DRAINAGE INFORMATION SHEET

PROJECT TITLE: Plat of Lands of Irene Blea ZONE ATLAS/DRNG. FILE #: K-12-Z 916
 LEGAL DESCRIPTION: Tracts 23B1, 23B2, 80C, # 22
 CITY ADDRESS: 418 ATRISCO DR SW,
 ENGINEERING FIRM: Gardner, Mason & Assoc CONTACT: Richard Mason
 ADDRESS: 2127 Menaul Blvd PHONE: 881-3846
 OWNER: Irene Blea CONTACT: Fred Sanchez
 ADDRESS: see below PHONE: 884-2036
 ARCHITECT: ↓ CONTACT: _____
 ADDRESS: _____ PHONE: _____
submitted for Fred Sanchez
 SURVEYOR: Albuquerque Surveying Company, Inc CONTACT: Fred Sanchez
 ADDRESS: 2119 Menaul Blvd PHONE: 884-2036
 CONTRACTOR: n/a CONTACT: _____
 ADDRESS: _____ PHONE: _____

DRAINAGE REPORT

LANDS OF IRENE BLEA

EXHIBIT "A"

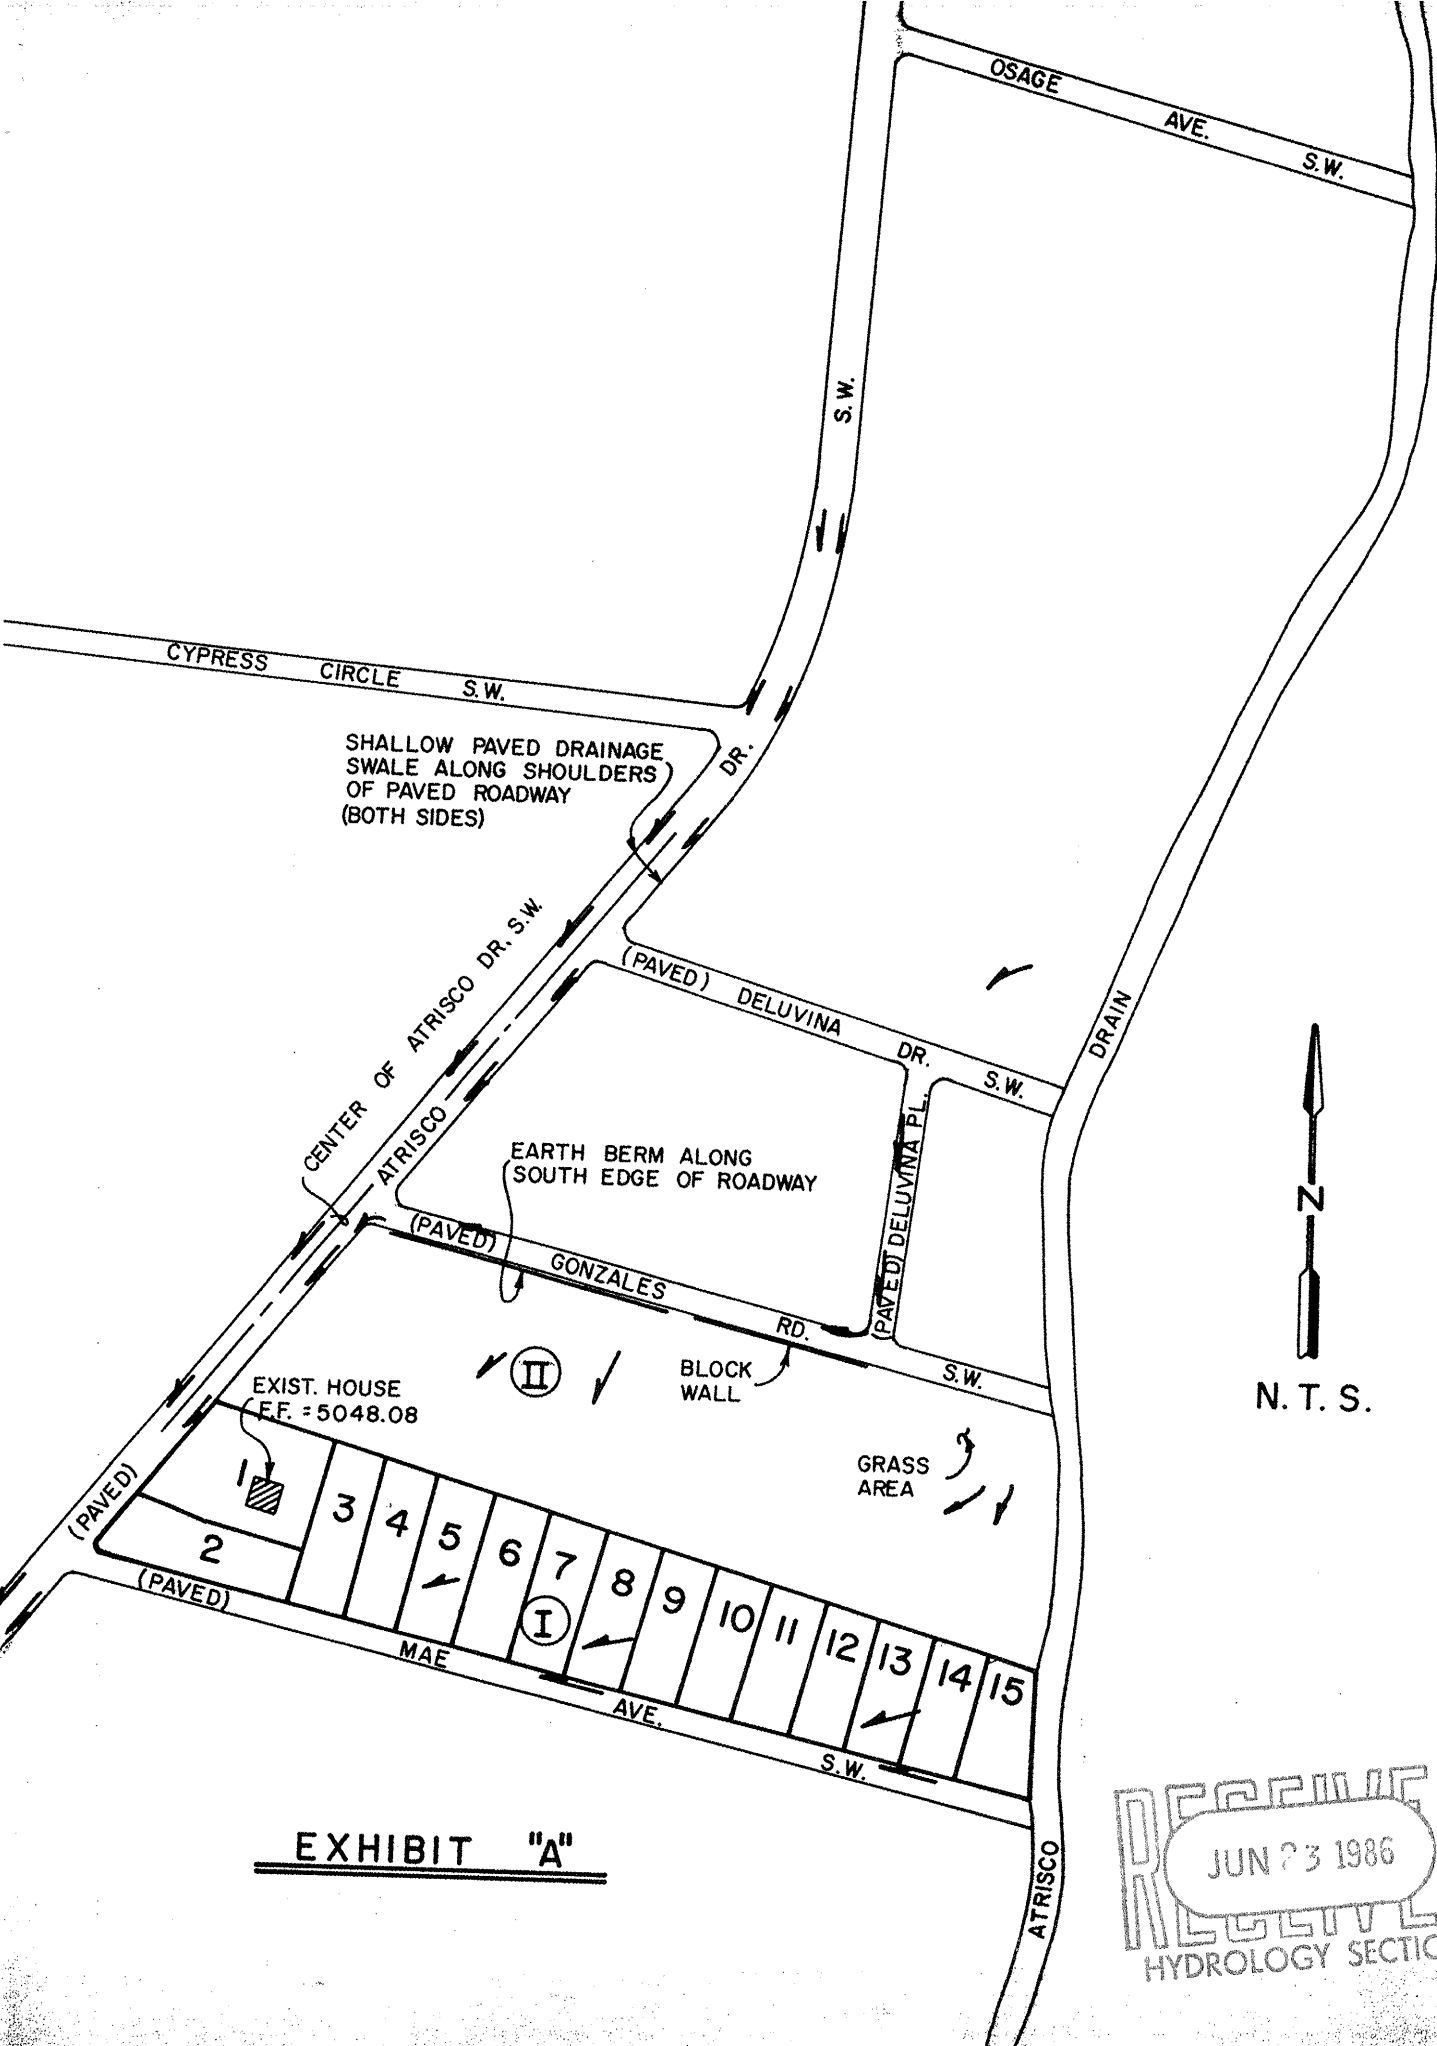
- A. Offsite flows draining into the site are insignificant and contribute little run-off to the site. For sizing of the ponds assume that 60 percent enters the site. *WHY?*

REPLAT
OF
TRACTS 23 B1, 23 B2, 80C, & 22
M.R.G.C.D. PROPERTY MAP NO. 39
(NOW COMPRISING LOTS 1 THRU 15)
LANDS OF IRENE BLEA
ALBUQUERQUE, BERNALILLO COUNTY, NEW MEXICO
GRADING AND DRAINAGE PLAN

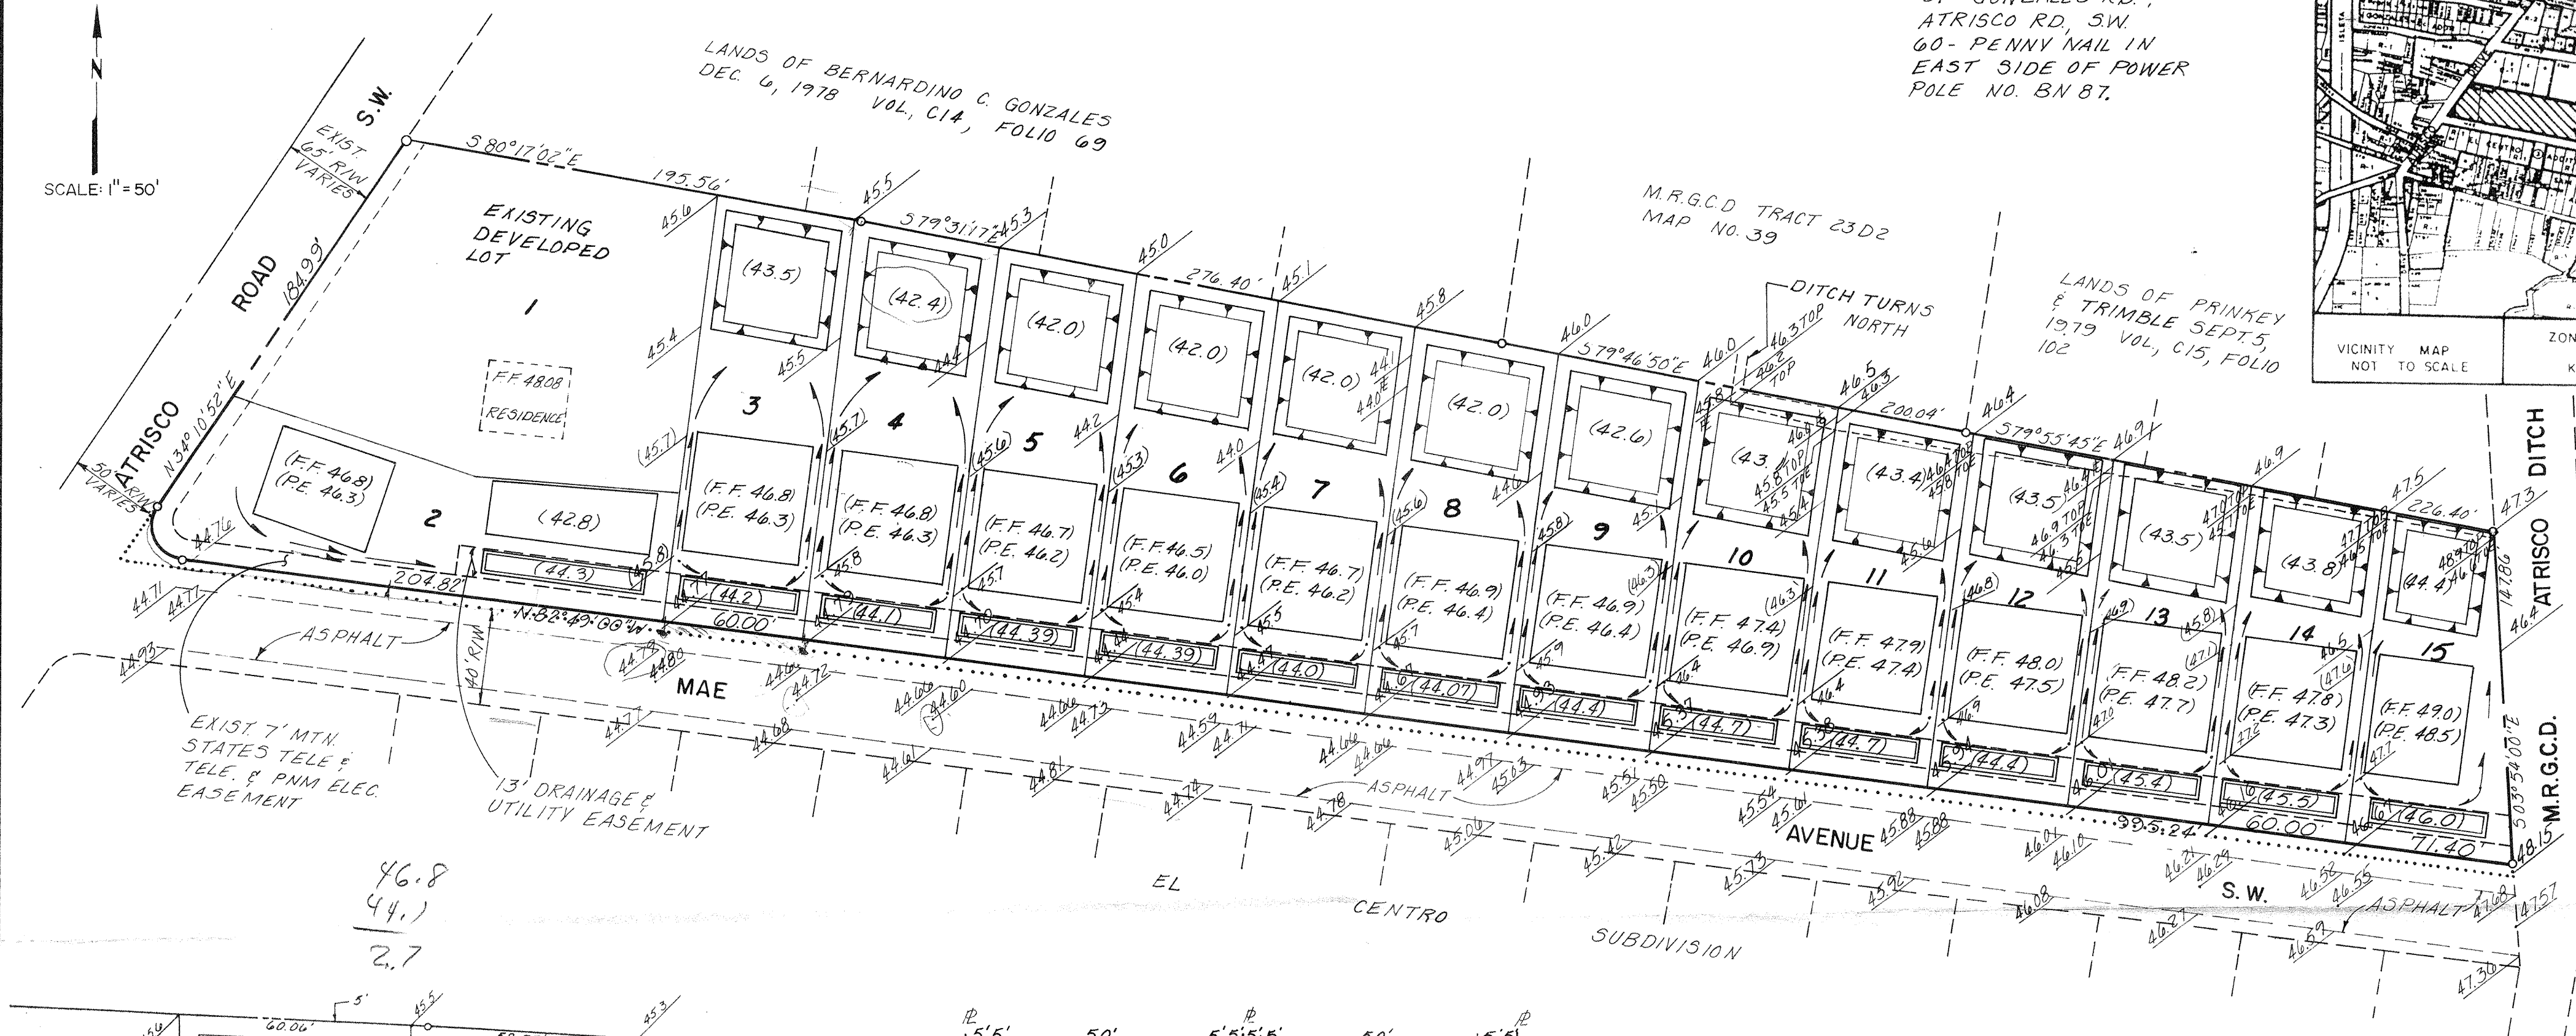
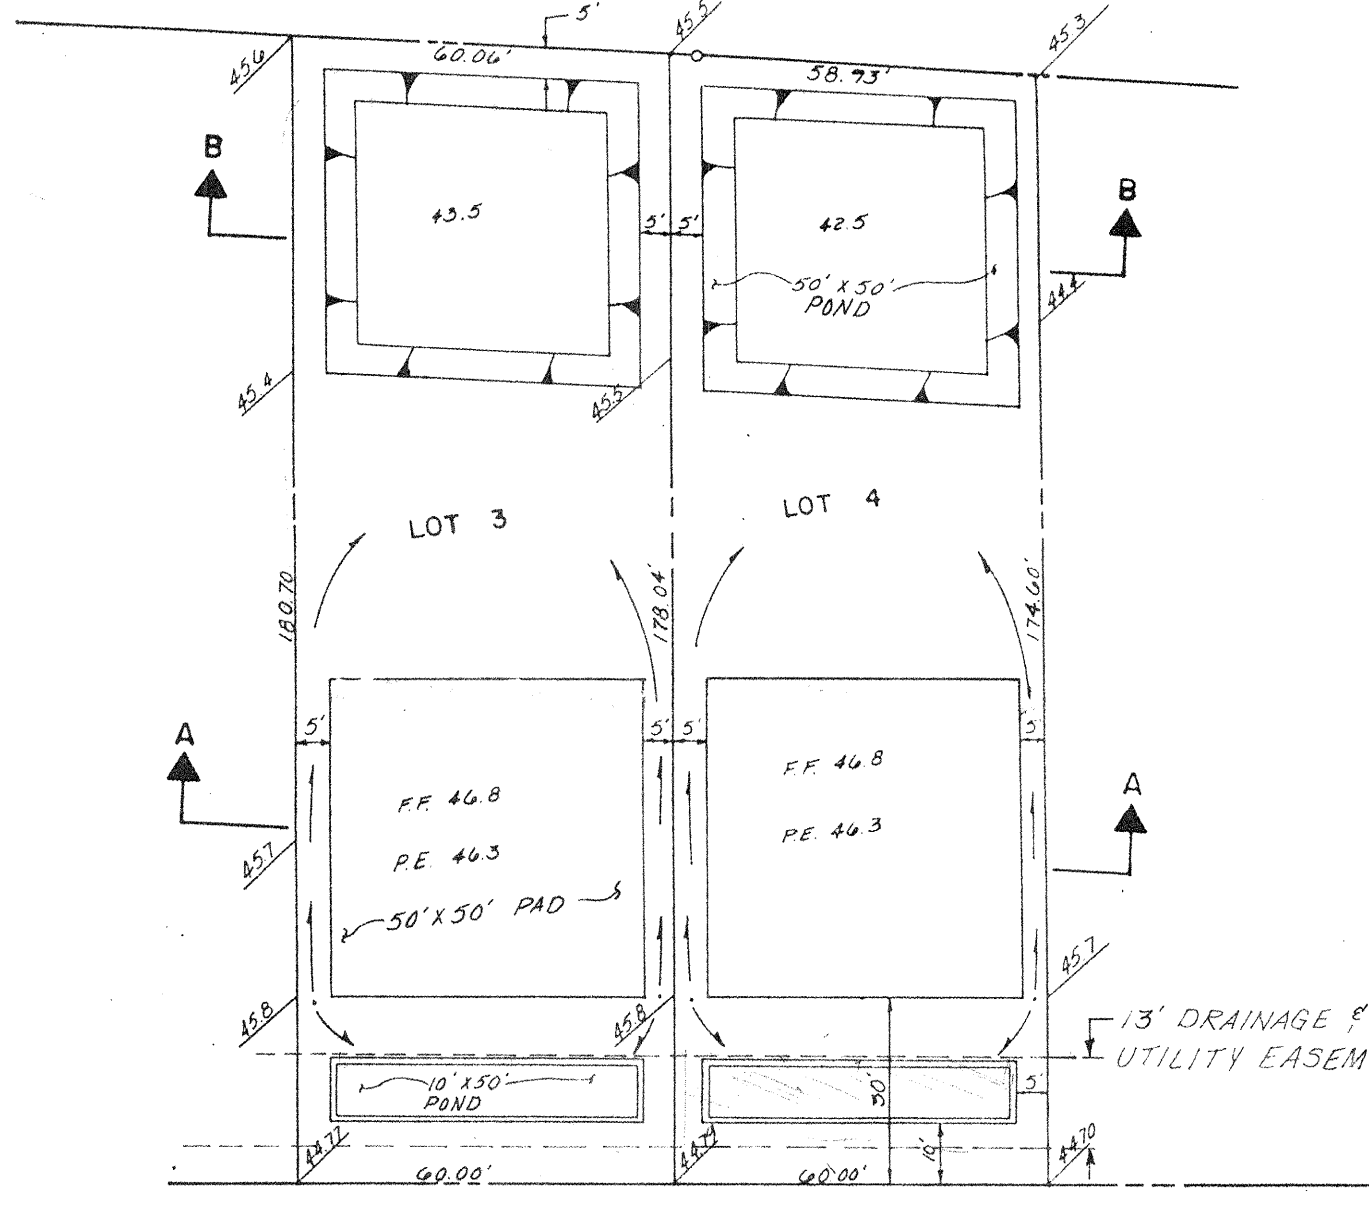
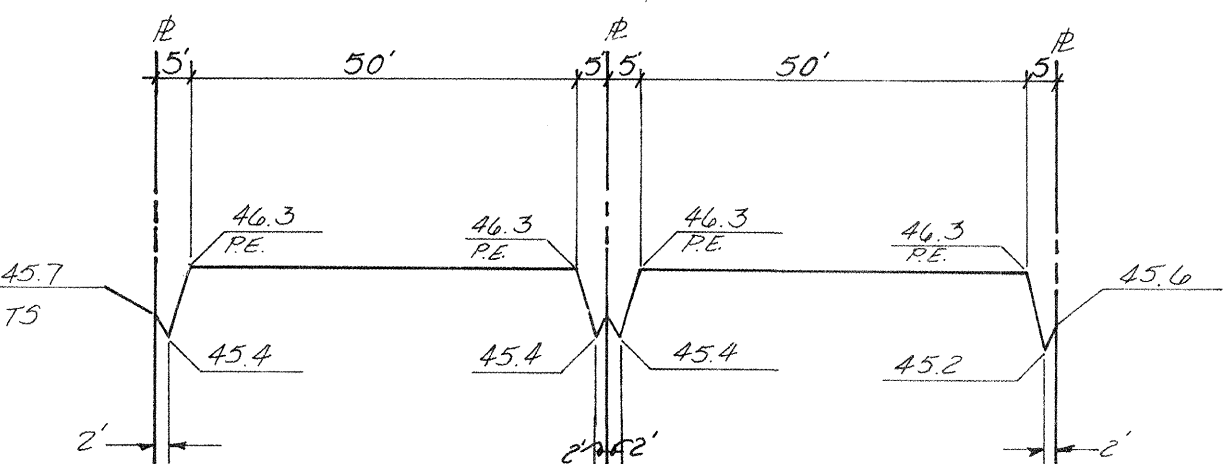
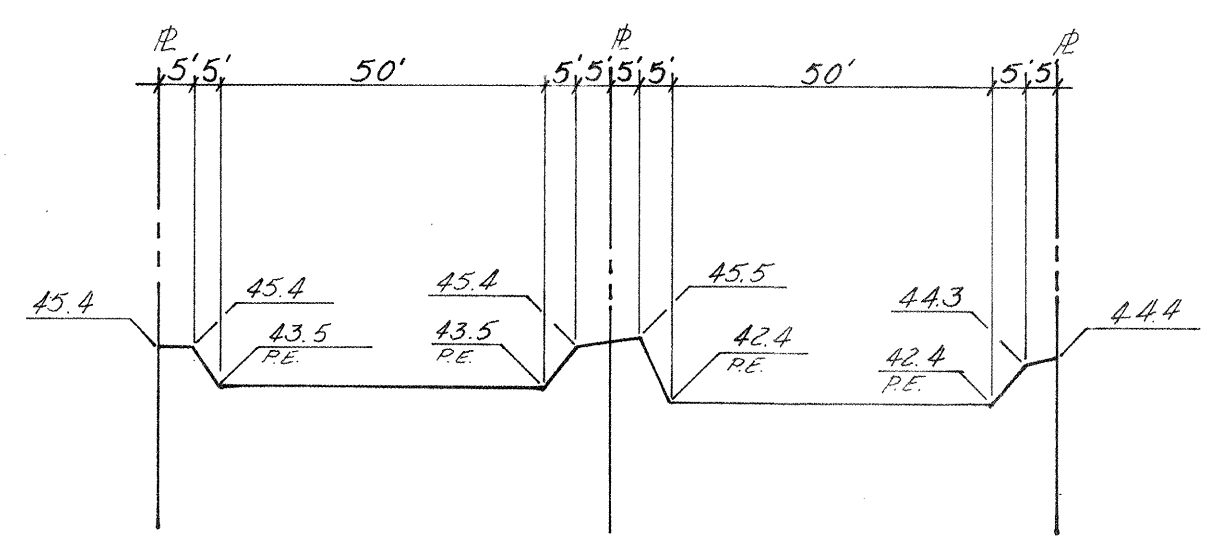
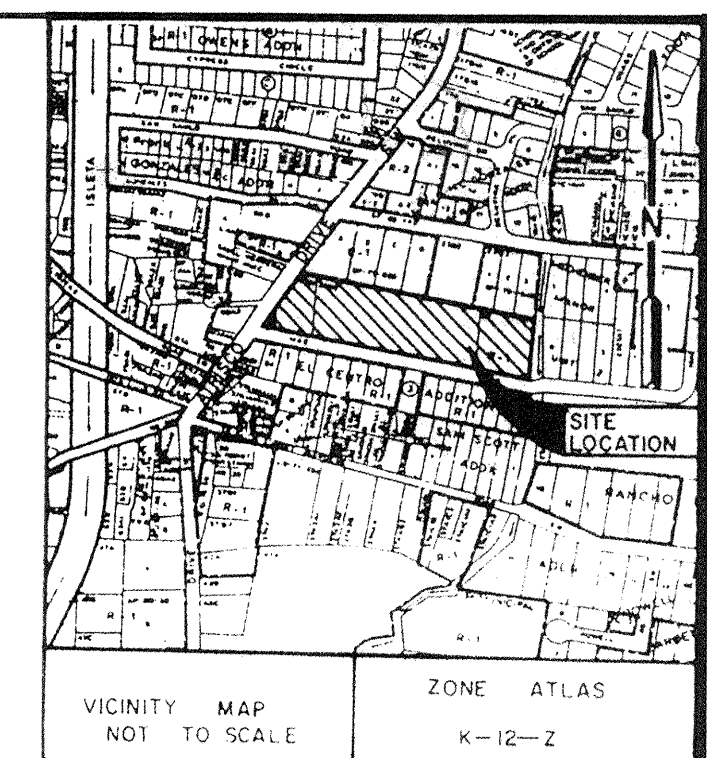
The plat submitted April 10, 1986, to DRB does not show the public drainage easement north of Mae Avenue. Also, required would be the construction and maintenance responsibilities.

Please be advised that any improvements to Mae Avenue will require a resubmittal of the drainage plan.

It appears that the pond volumes are conservative. However, any changes in the volume will require a more detailed submittal of off-site flows and 100 year floodplain elevation.
